Accredited Standards Committee
X3, Information Processing Systems

Doc: X3T10.1/96a142r1
Date: July 15, 1996
Project: X3T10.1/1146D
Ref Doc.: SSA-PH2 rev 1
Reply to: John Scheible

To: X3T10.1 Membership
From: John Scheible
Subject: SSA-PH2 changes proposal

Figure 6 - Test environment for drivers

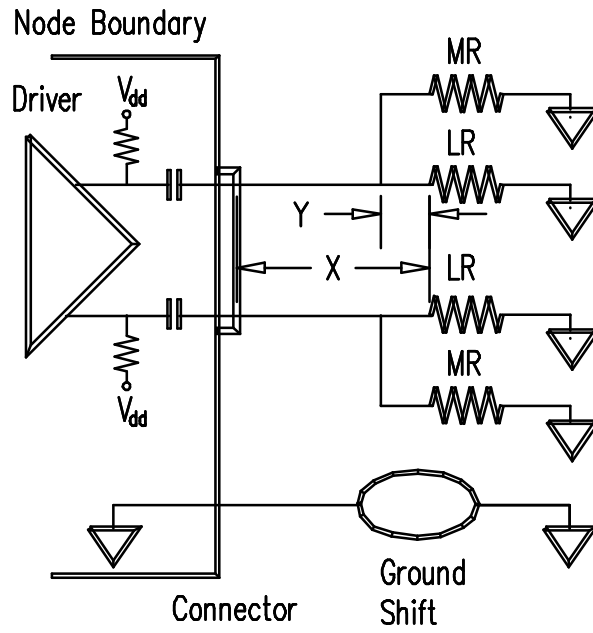
- a) A new sub clause 7.1.6 as defined below.
- b) Modify Figure 6 as shown below.
- c) Change the first paragraph of 7.1.3 to...

Line drivers shall be tested using the test circuit shown in Figure 6. Line Driver measurements shall be made at the port connector. The distance between the port connector and the load resistance LR (labeled X in Figure 6) shall not exceed 5 cm. The distance between the measurement point and the load resistance LR (labeled Y in Figure 6) shall not exceed 5 mm. The difference between the X values of the LineOut+ and LineOut- lines of the driver shall not exceed 5 mm. The resistance of the combined load resistance LR and measurement resistance MR shall be $75 \Omega \pm 2\%$. The connecting media shall meet the requirements in 7.5 for this test. The total additional capacitive load from the scope probing scheme between Line+ and ground and between Line- and ground at the port connector shall be $2 \text{ pF} \pm 20\%$. This capacitance includes the sensing probes and equipment added to enable probing. Additional discrete capacitors between the scope probes and the port connector ground may be needed. The load shall conform to the characteristic impedance requirements in 7.3 at its connector.

7.1.6 Line Driver termination

The LineOut+ and LineOut- lines of the Line Driver shall be terminated between the driver and the series capacitor with terminating resistors of $75 \Omega \pm 1\%$ connected to the terminating voltage (see Figure 6). The series capacitor between the terminating resistor and the connector shall have a value of TBD when measured with the measurement scheme specified in TBD.
